MARK	DATE	DESCRIPTIONS	BY	CH'D	CCO#
2	02/17/12	CABLE TRAY COVER AT W2	RSB	RG	234
1	11/20/09	ELECTRICAL GROUNDING	RR AWG	RG FW	75
0	02/25/08	CABLE TRAY CHANGES	TW	RG SE	42S1

CONTRACT CHANGE ORDER NO._____
SHEET _____ OF _____

DETAILS
UNDERGROUND
PIER W2E PLANS AND SECTIONS
SCALE AS NOTED

E-21B

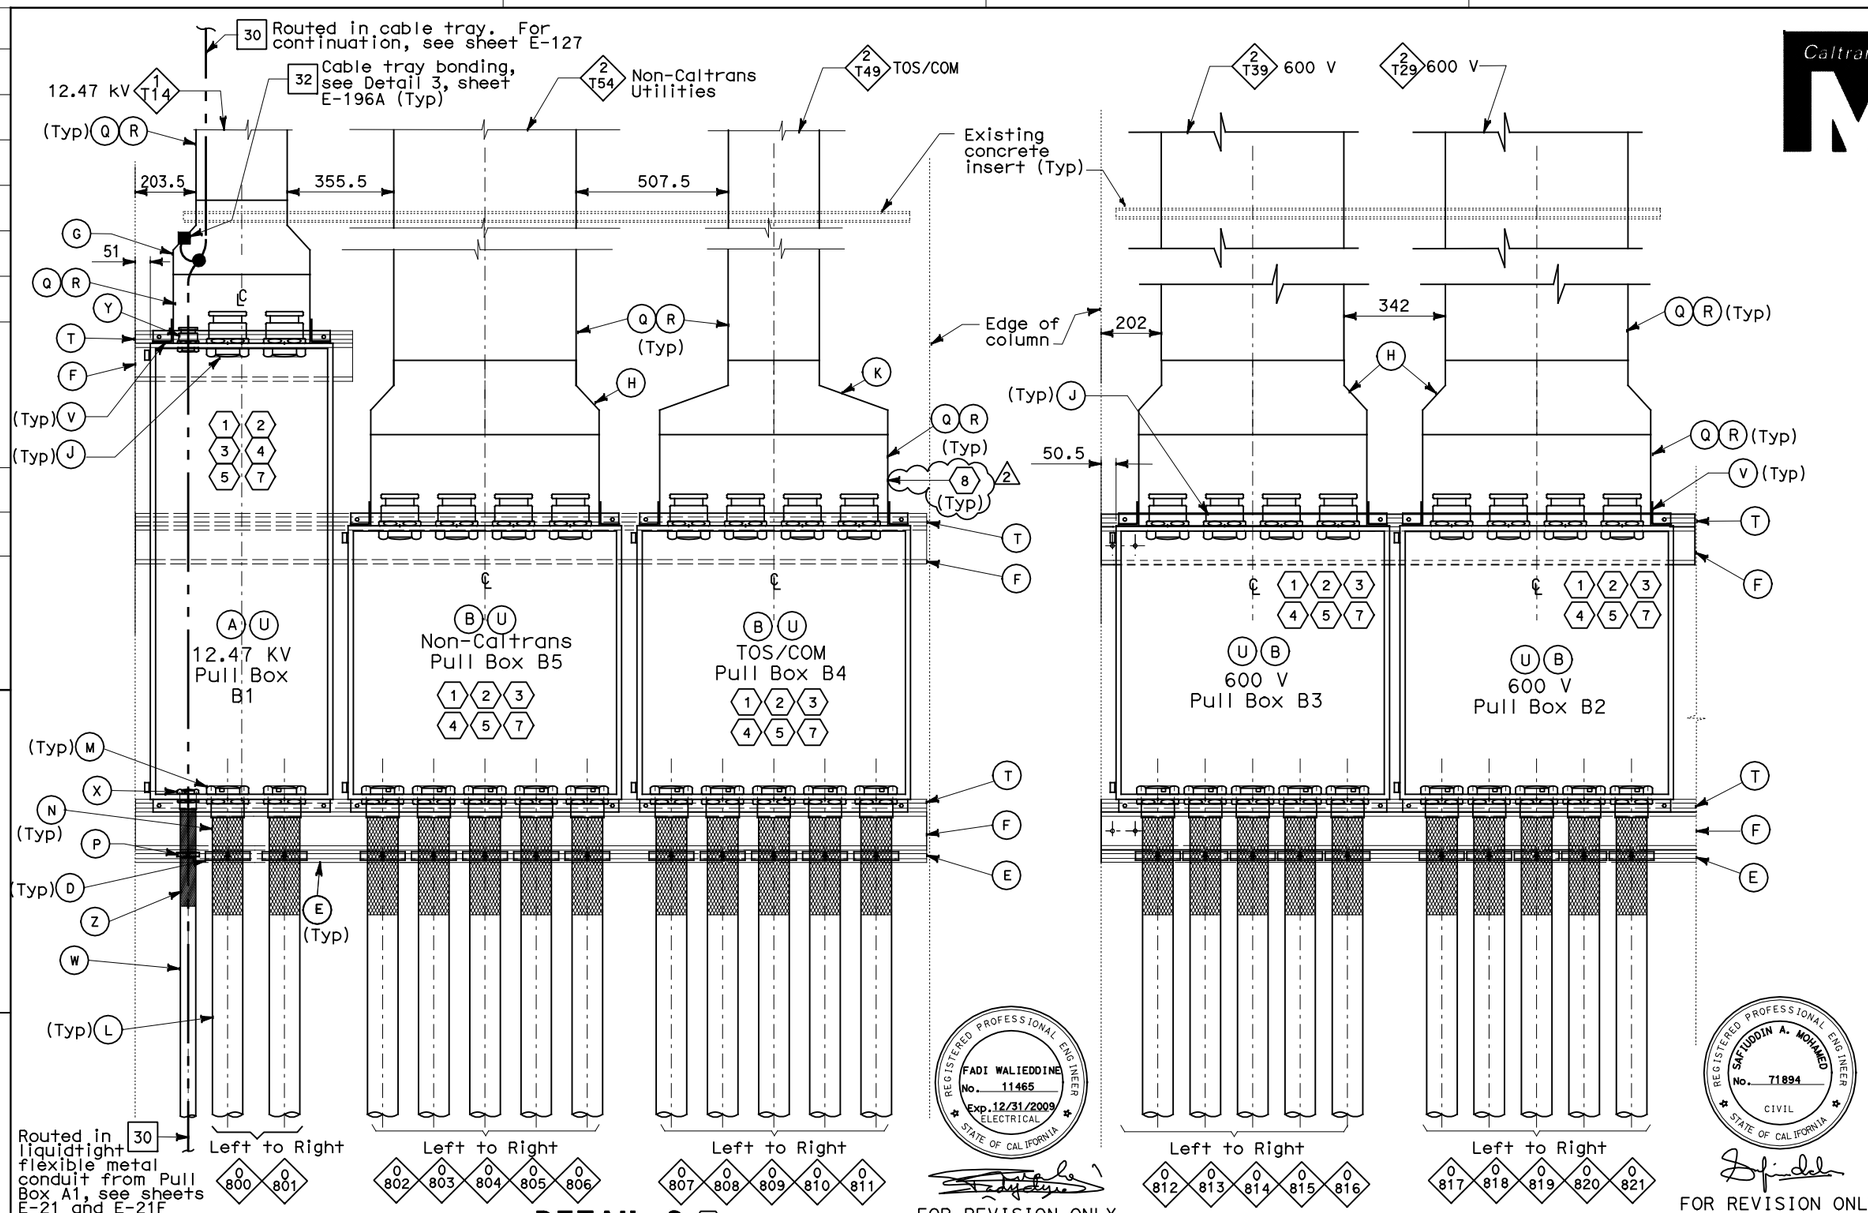
(2) (8) For vertical cable tray not flush with the pier column wall, Contractor shall provide solid flanged cover on top and bottom of cable tray with approved heavy duty cover clamps.
